Public Hearing: Larsen Subdivision

Preliminary Plat, Boundary Line Adjustment, Tree Removal, Mitigated SEPA DNS, Critical Areas Review and
Public Hearing: Type III Review

Staff Report & Recommendations

(#2024-003-SUB/SEPA/BLA/CAR/TRE)

Figure 3 – Proposed Preliminary Plat

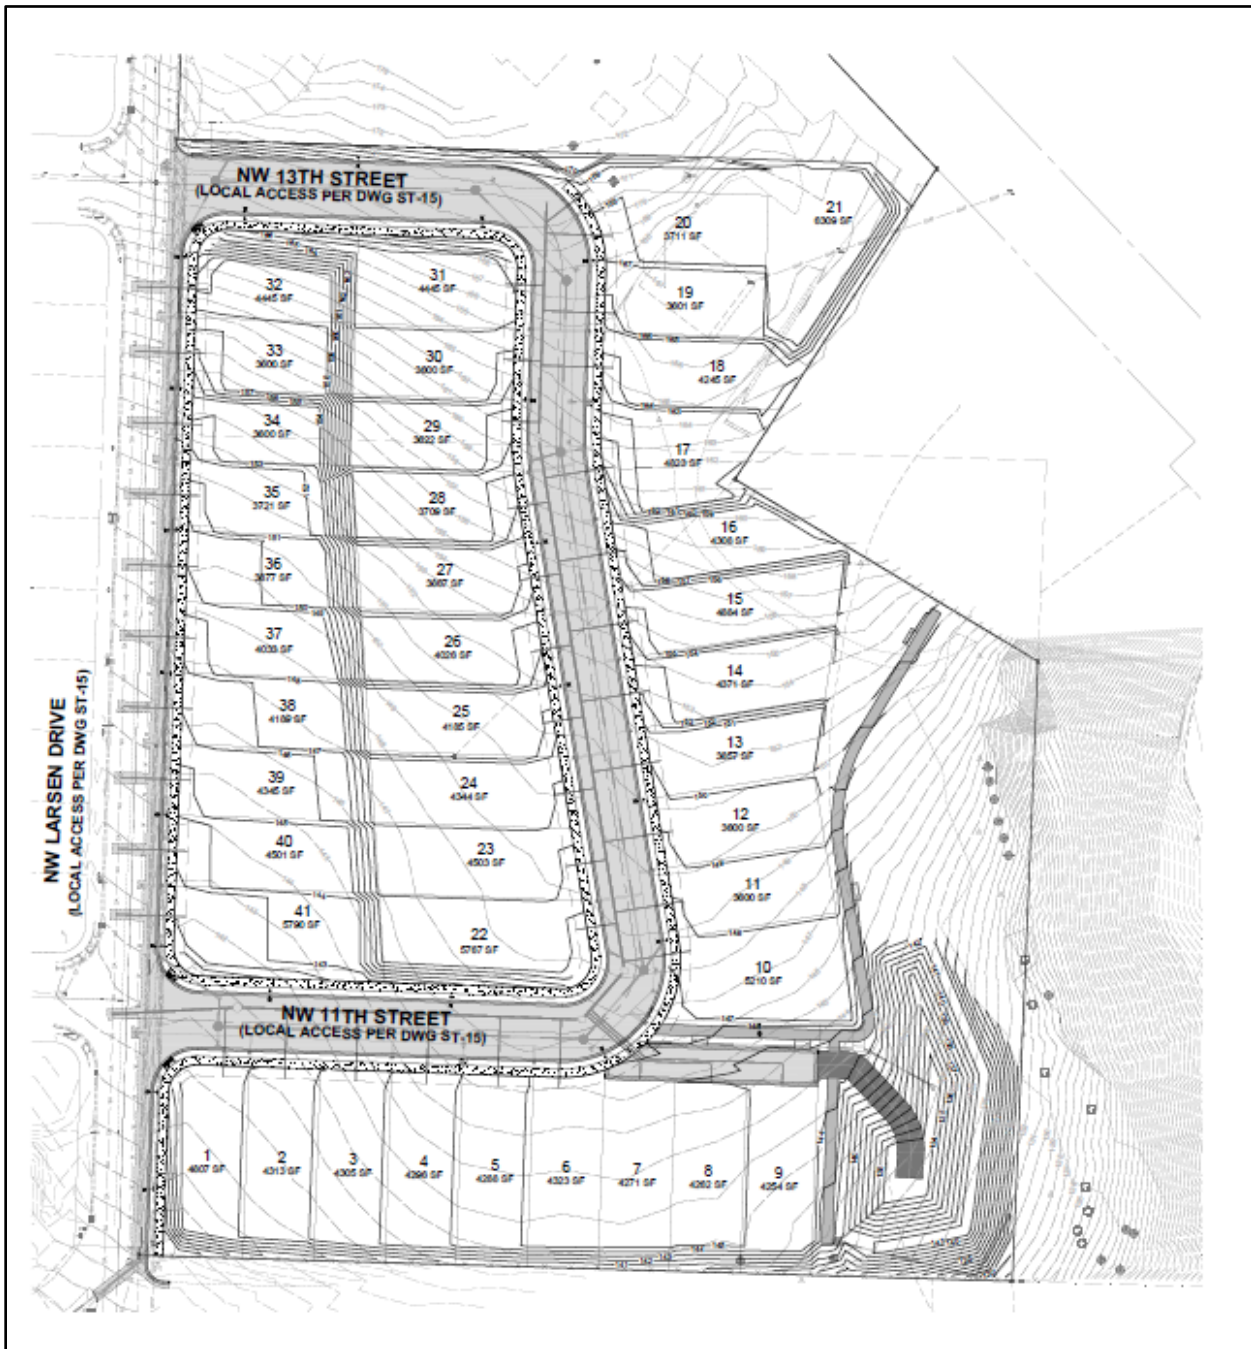
- The undeveloped play area is mostly covered by seed or sod and trees, and no irrigation is shown.
- The applicant's park plans do not show a low fence or vegetative barrier adjacent to lots 9-15. A condition of approval will require a low fence or vegetative barrier adjacent to these lots.

As a **condition of approval**, the applicant's final park plan shall show a low fence or vegetative barrier where the park abuts residential lots.

Storm and Sewer Plan

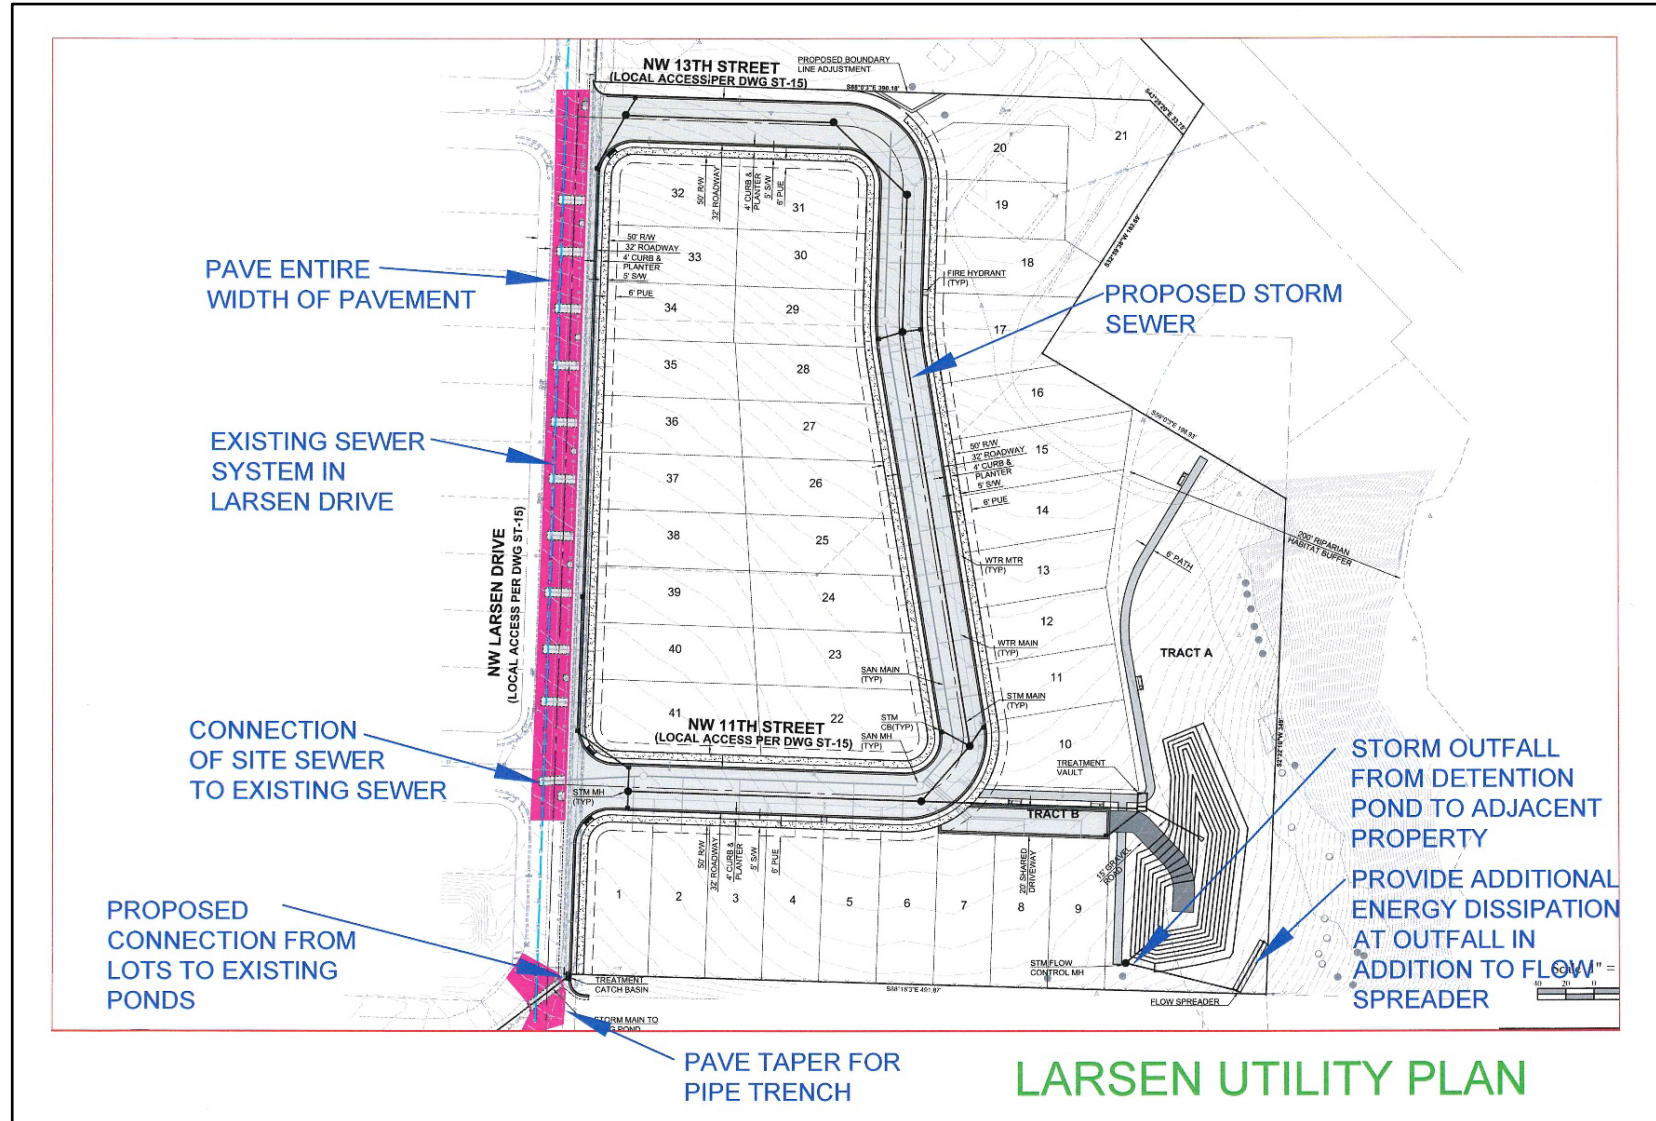
- Access to the stilling will may be difficult. From the plans it looks like the grading plan shows a 12-foot wide level top of pond pad on the east side of the pond. The contours on the east side of the pond appear to be 2:1 or 3:1 slope. The Geotechnical Report recommends a maximum site fill slope of 2:1, but 4:1 may be better for easier access to the outlet structures, and easy access to the structures.

- b. Access to the stilling will may be difficult. From the plans it looks like the grading plan shows a 12-foot wide level top of pond pad on the east side of the pond. The contours on the east side of the pond appear to be 2:1 or 3:1 slope. The Geotechnical Report

Photometric Plan

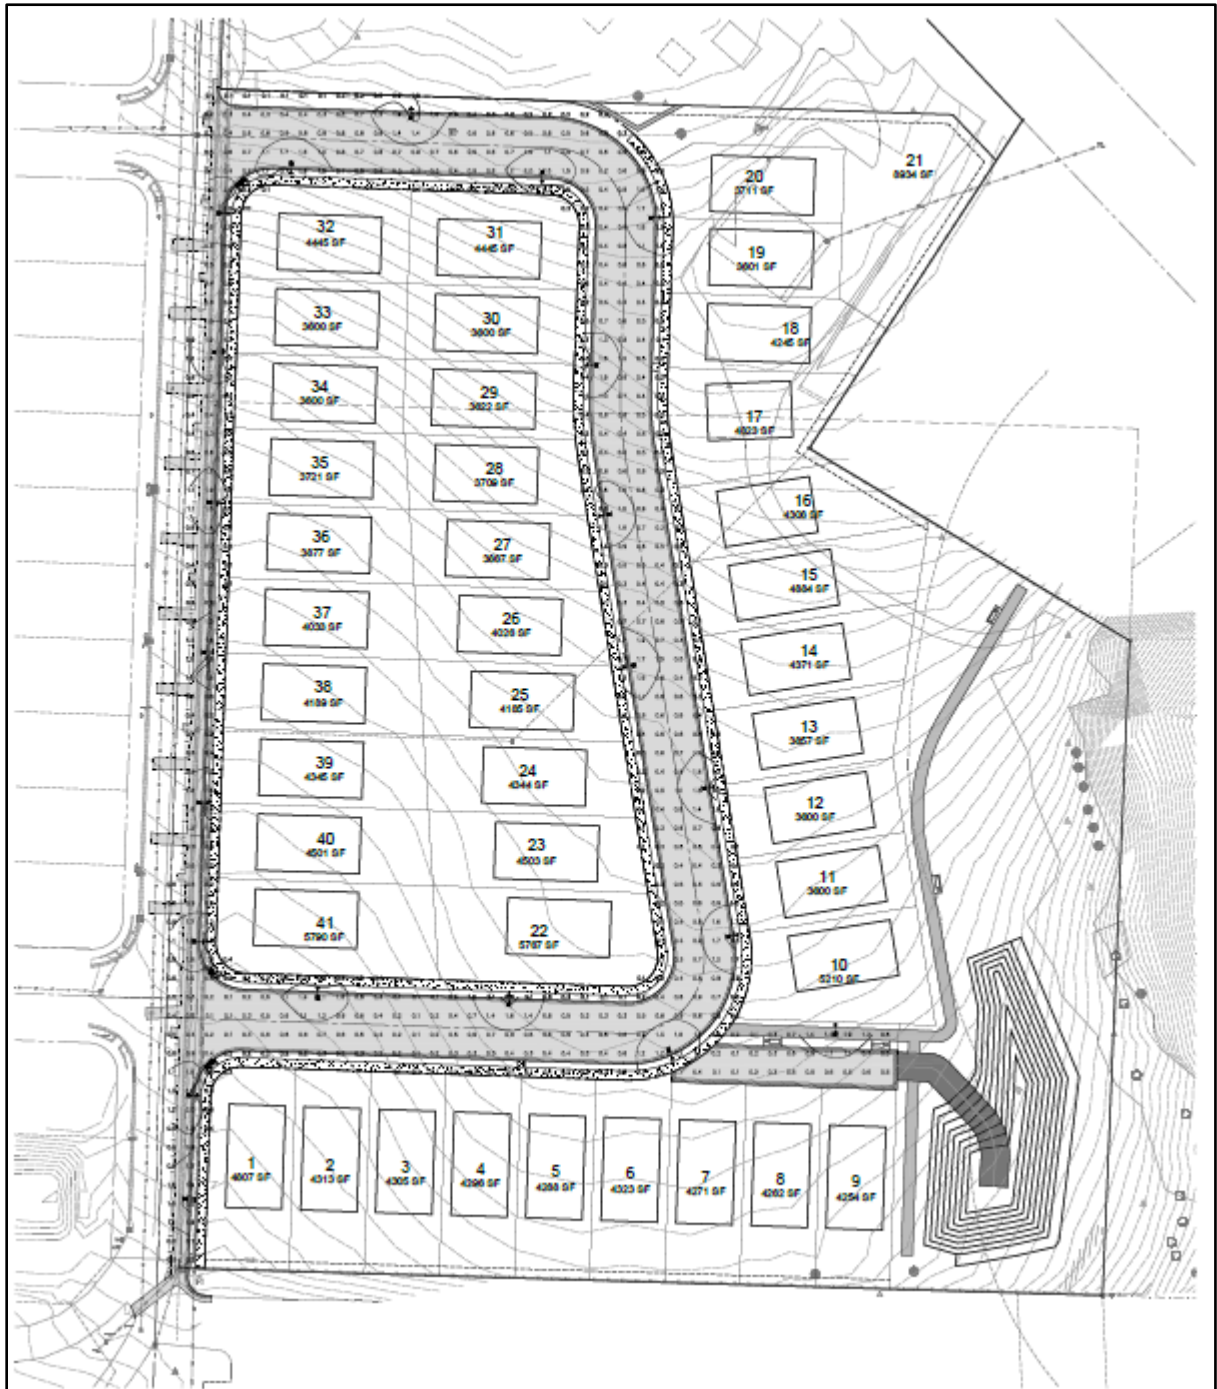
The applicant is proposing street lighting with the project and has submitted a preliminary lighting/photometrics plan. The proposed lights will not cause more than a one foot-candle measure at any property line in conformance with 18.245.040 and LCMC 18.282.
